**ADDENDUM #3**

**TO CONTRACT DOCUMENTS FOR:** Project #CP221611 – Patient Care Tower -  
Radiology Expansion

**PREPARED FOR:** The Curators of the University of Missouri

**MP-122 - A**

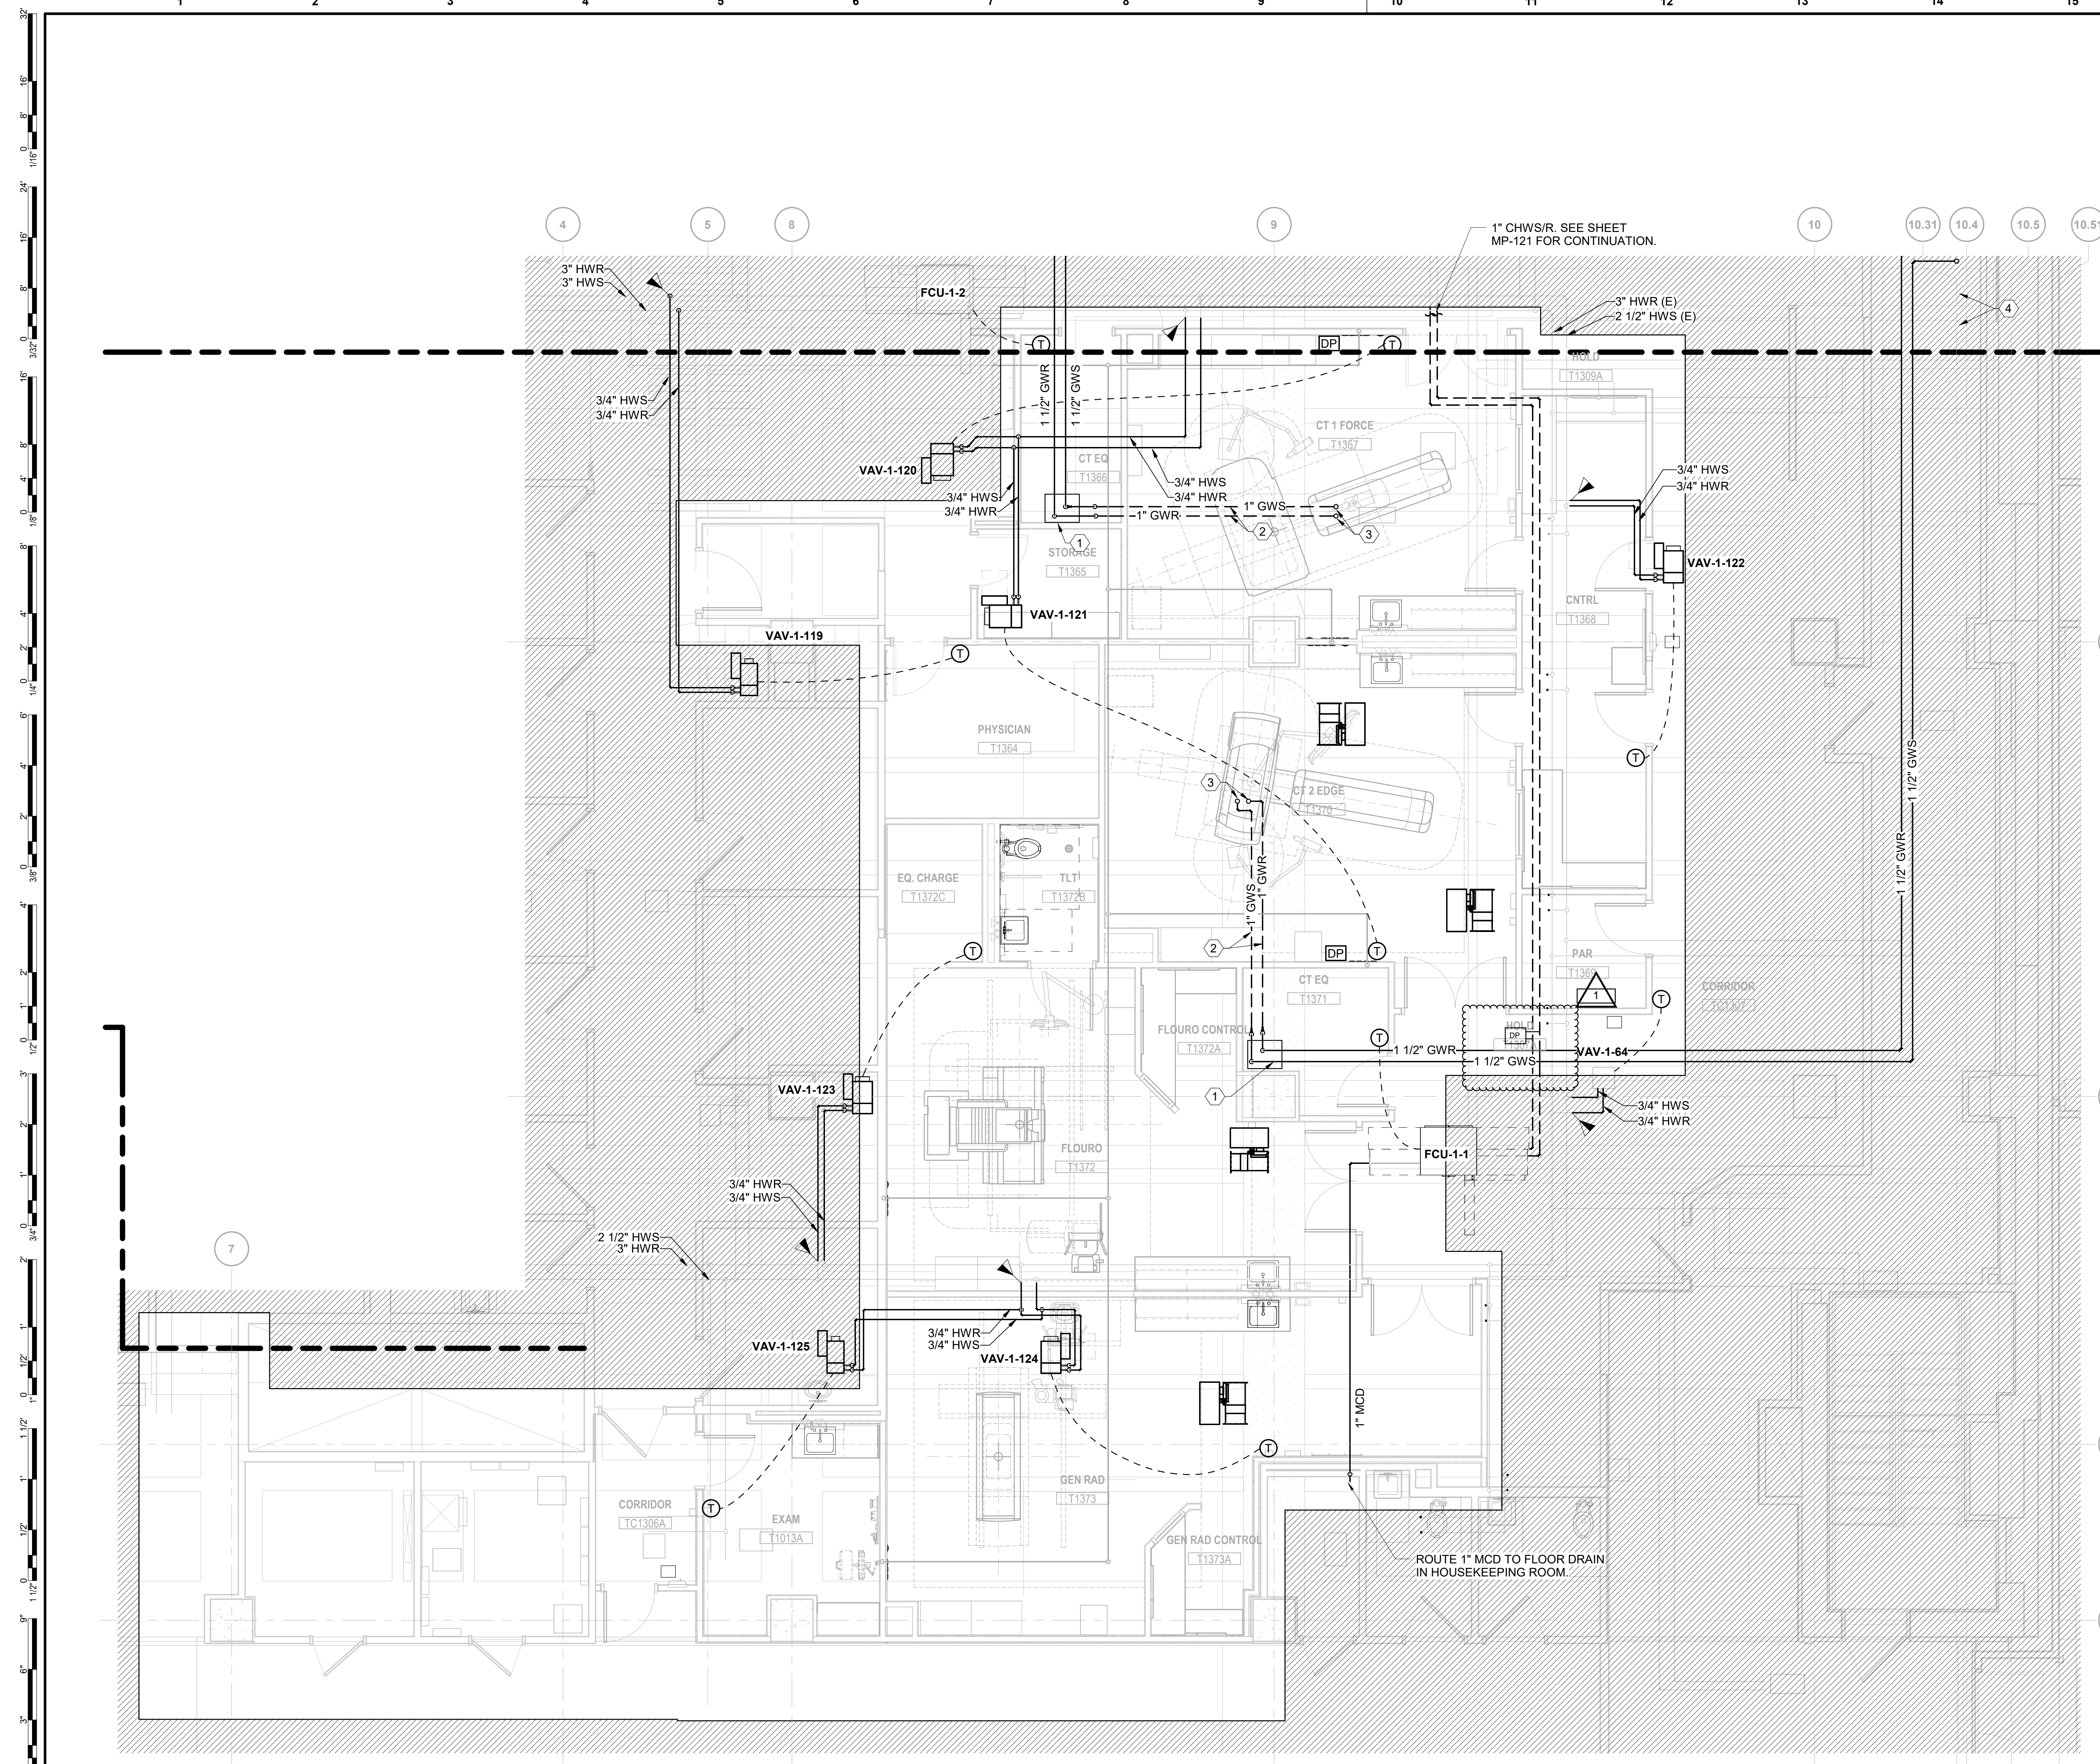
- 1) Mechanical Drawing MP-122-A: DPT location added.
- 2) Sketch: DP Monitor Detail attached.
- 3) Architectural Drawing A-123-A: Annotation plan keyed note 5 removed.
- 4) Piping Drawings PD-122-B: Additional piping demolition noted.

- 6) Bidder Question: The chilled water control point diagram (Sheet MH-505) Keyed Note 1 directs the contractor to install the DPT where shown on plans. No location is shown on piping plans. Please provide location.
  - a. Design Team's Response: Location added to drawing Sheet MP-122-A.

- 8) Bidder Question: Bidder Question: Sheet MP-122-A floor plan indicates that there are two (2) room pressure monitors (DP) located at Rooms CT-Force 1 and CT-Force-2. These are not shown on the MH-504 and MH-505 control schematics. If required, please specify type and if BAS communications are required. IF BAS communications are

- a. Design team response: Room pressure monitors are required at the two (2) CT rooms. Please see attached “DP Monitor” PDF. Room differential pressure devices shall be TSI PresSura or equal by Accutrol, Siemens, or Setra.

LEVEL 1, PHASE 3, AREA A & B - FLOOR PLAN	
BMCD project #: 143839	MU project / contract #: CP221611
drawing <b>A-123 - A</b>	rev.

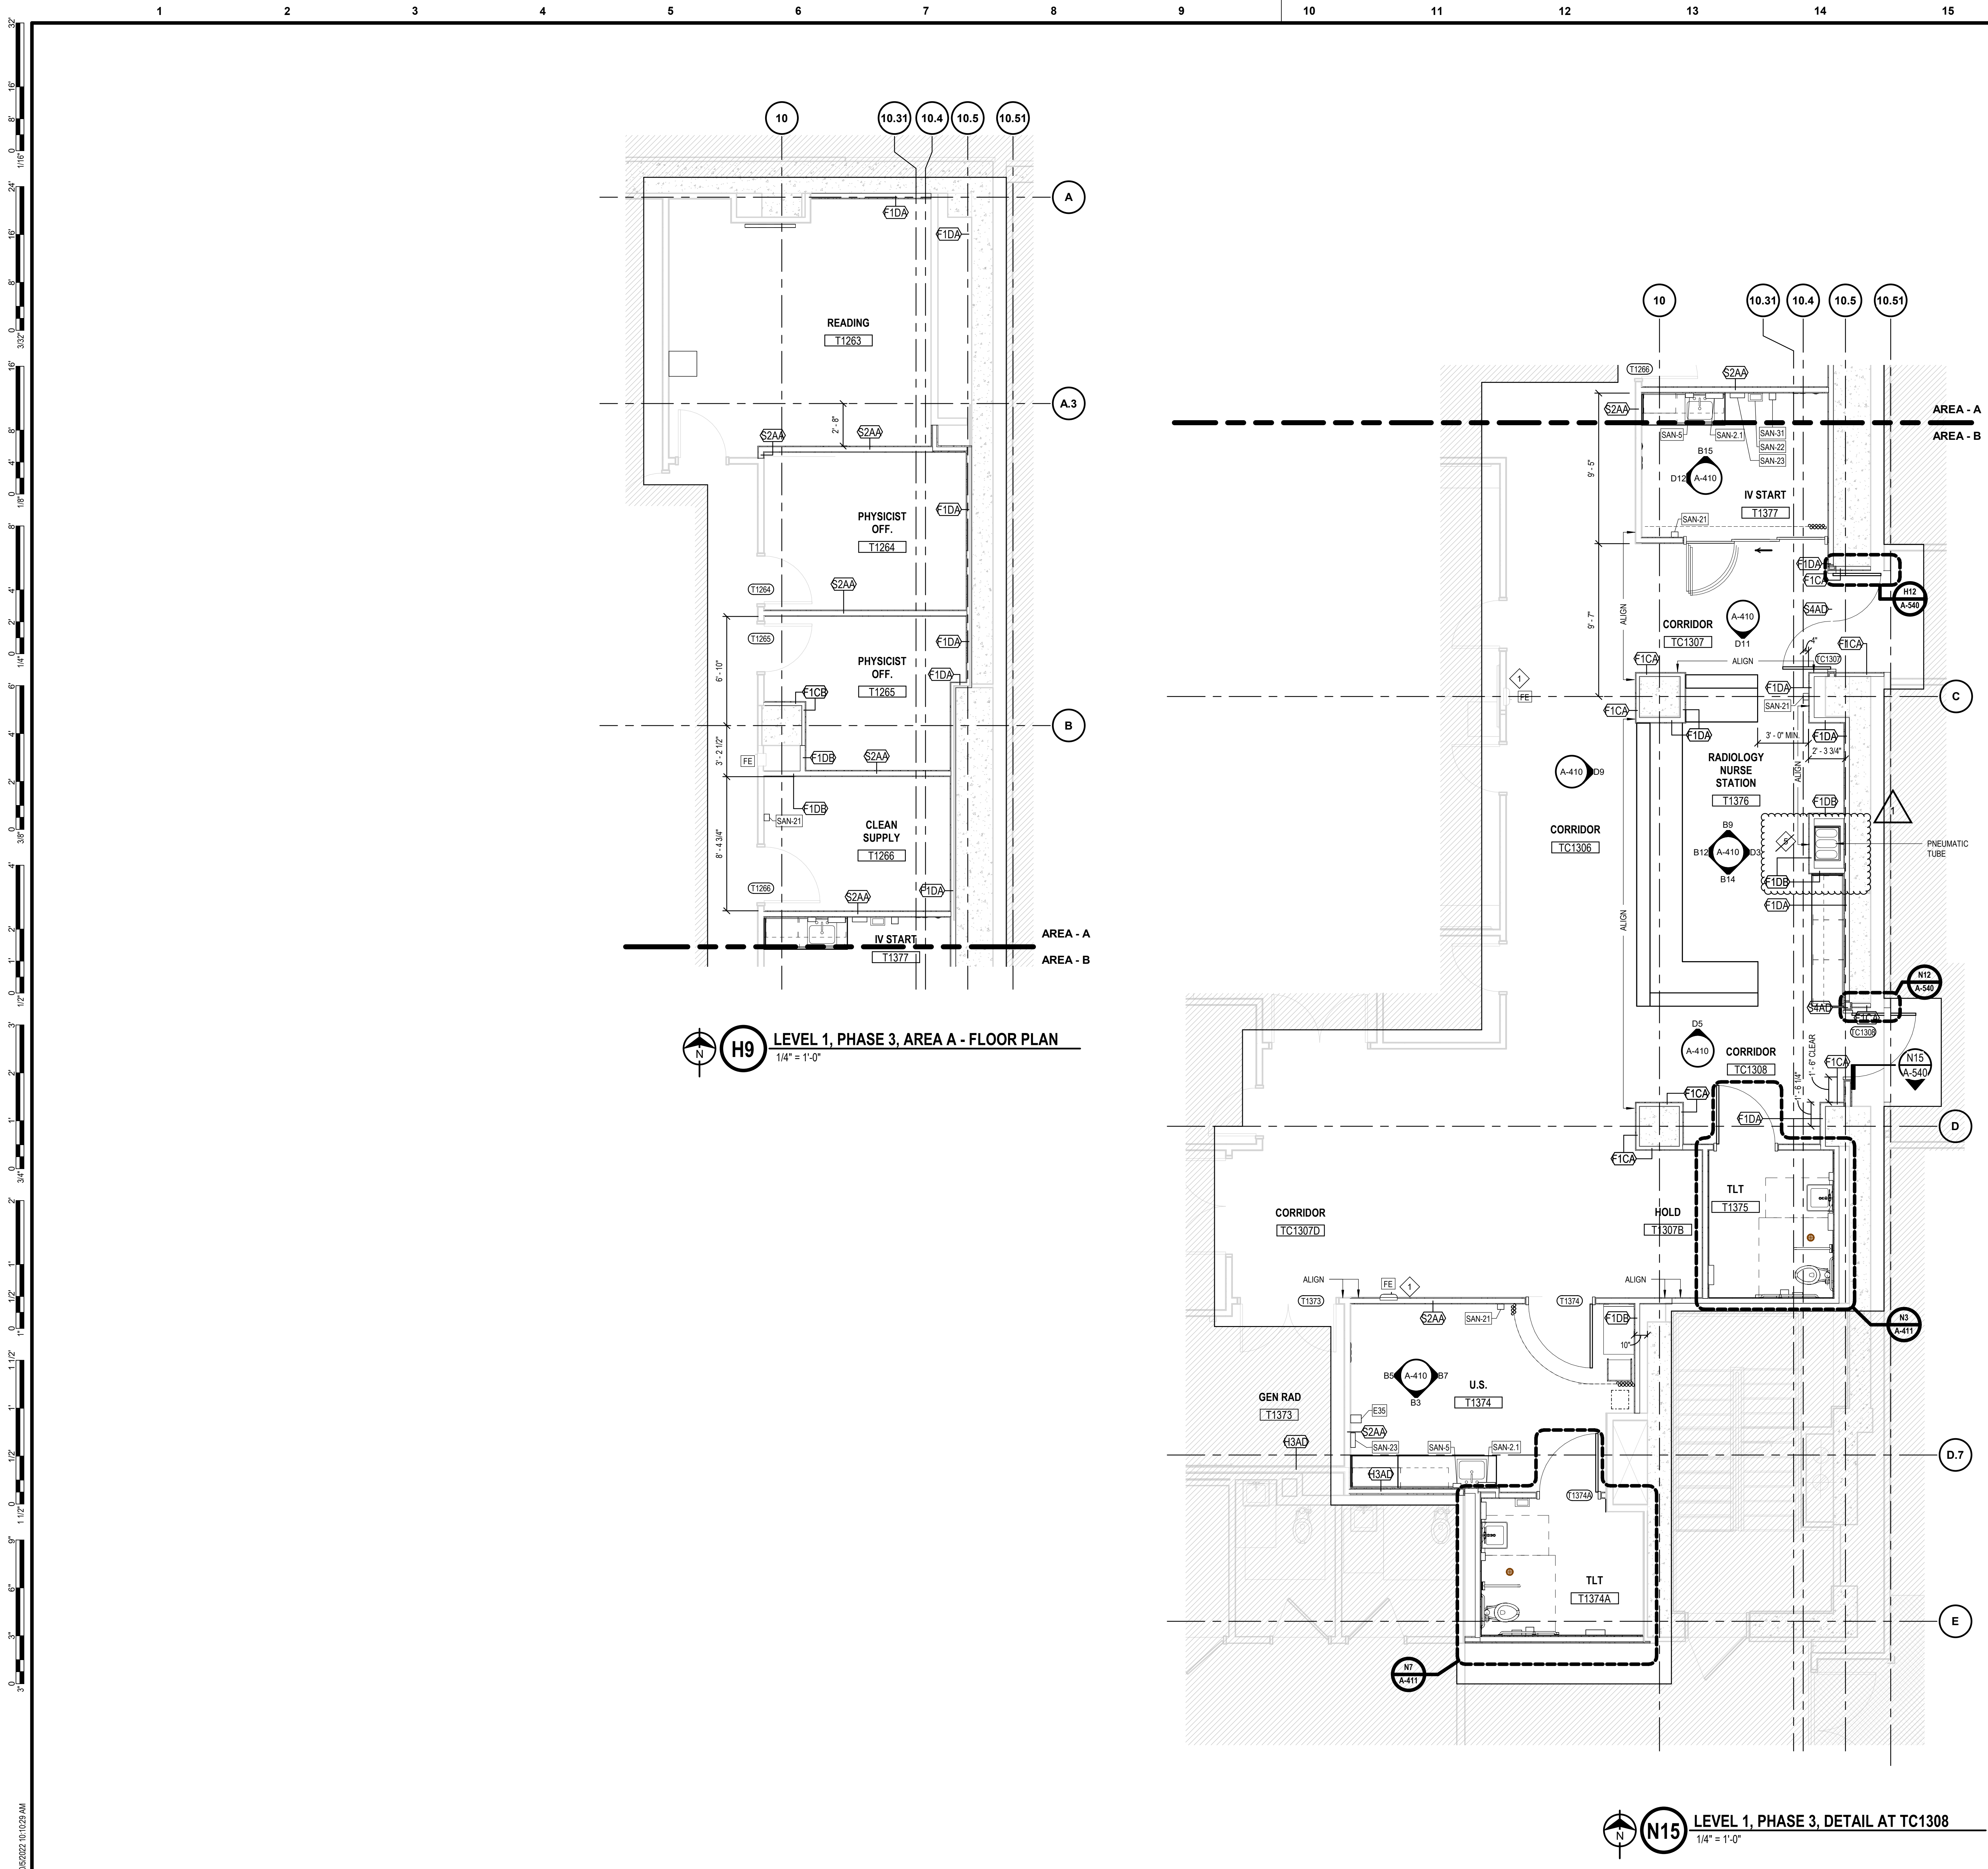
- 9) Bidder Question: On sheet A-123-A on Keynote 5 says “pneumatic tube station, RE: v-sheets”. No V-sheets are in the current document set.
- a. Design team response: Pneumatic tube station is an MU vendor. No v-sheets provided in construction documents.
